# SERVICE BULLETIN

HF-380 TRANSCEIVER (622-3580-001)  
KWM-380 TRANSCEIVER (622-5093-001)  
SYNTHESIZER VARIABLE REFERENCE FREQUENCY LOOP A5A2 (638-6920-001)

SERVICE BULLETIN NO 16  
(SUPERSEDES SERVICE BULLETIN NO 3)

ELIMINATE FREQUENCY WARBLE AND REDUCE 500-Hz SIDEBANDS  
ON INJECTION FROM SYNTHESIZER

P/O Synthesizer Variable Reference Frequency Loop A5A2  
Figure 1

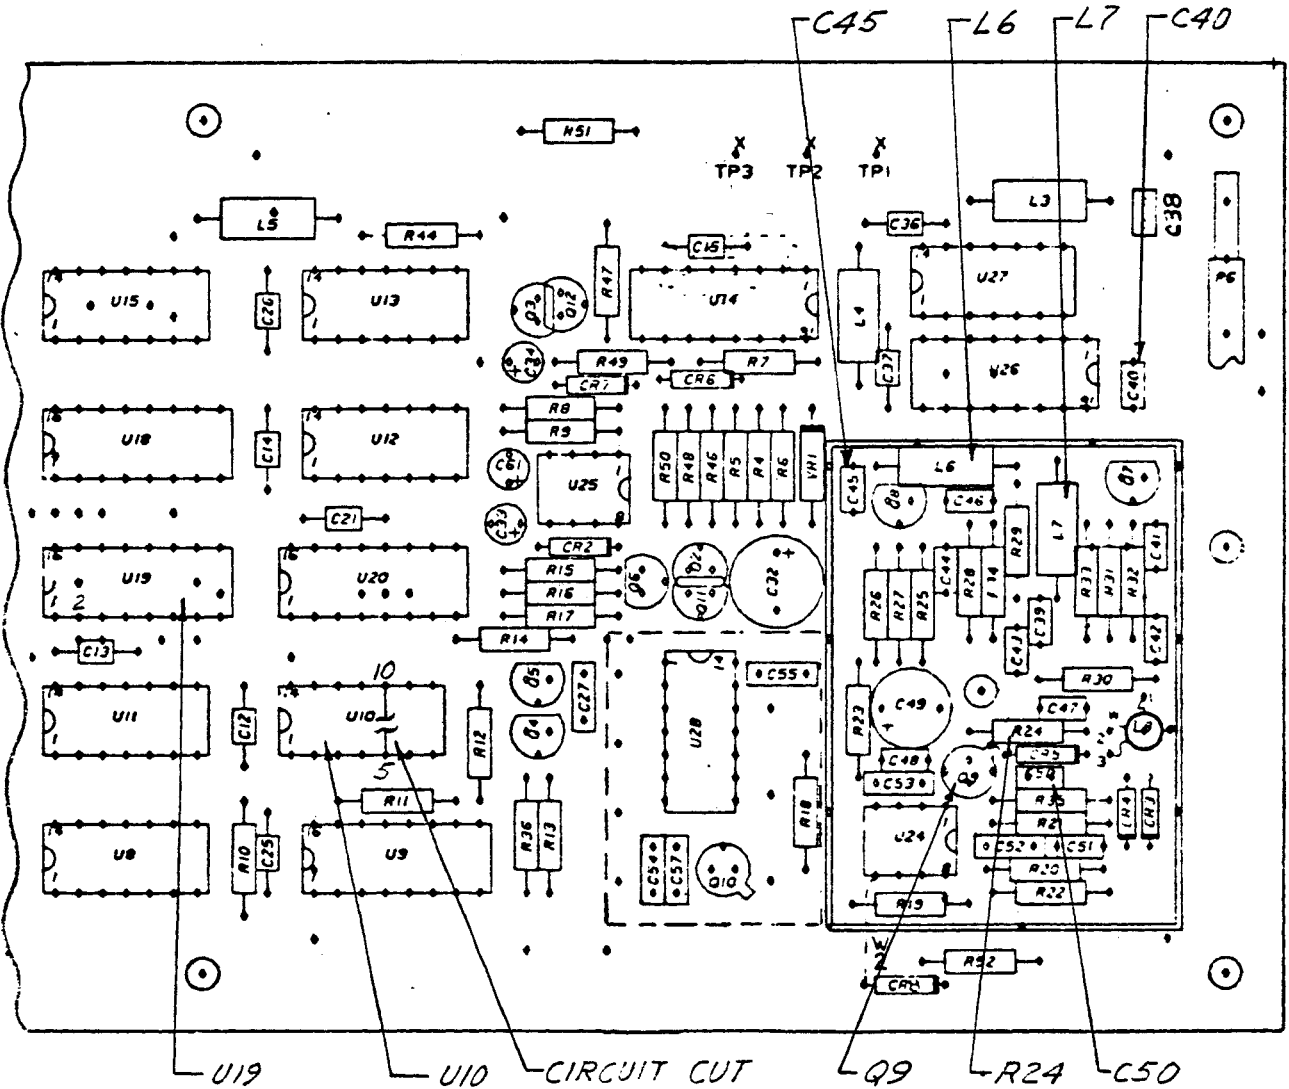
A frequency warble may occur at certain frequencies in some radios. The warble will usually occur at the top end of each 1-MHz band. The problem has been traced to two integrated circuits on synthesizer variable frequency loop A5A2. When U14 and U26 are at the low end of their specified parameters, a low rf input may cause them to miscount. Steps F through L of the modification procedure will correct this problem.

**NOTE: Refer to figure 1 for location of components. Refer to figure 2 for a schematic diagram showing the revised U10/U19 connections.**

- F. Remove 4-pF capacitor C40 and replace it with a 12-pF capacitor (912-4141-120).
- G. Remove 4-pF capacitor C45 and replace it with a 12-pF capacitor (912-4141-120)
- H. Remove transistor Q9 (2N5486) and replace it with a 2N5397 transistor (352-0998-010).
- I. Remove 0.15- $\mu$ H coil L6 and replace it with a 0.10- $\mu$ H coil (240-2723-140).
- J. Remove 0.15- $\mu$ H coil L7 and replace it with a 0.10- $\mu$ H coil (240-2723-140).
- K. Remove 47-pF capacitor C50 and replace it with a 27-pF capacitor (913-1098-570).
- L. Remove 154- $\Omega$  resistor R24 and replace it with a 56- $\Omega$  resistor (745-0704-000).
- M. On the bottom of the card, cut the circuit trace which connects U10-5 to U10-10.
- N. Install a jumper wire (428-0282-050) from U19-2 to U10-5 on the bottom of the card.
- O. Mark SB 16 on the circuit card near the part number.
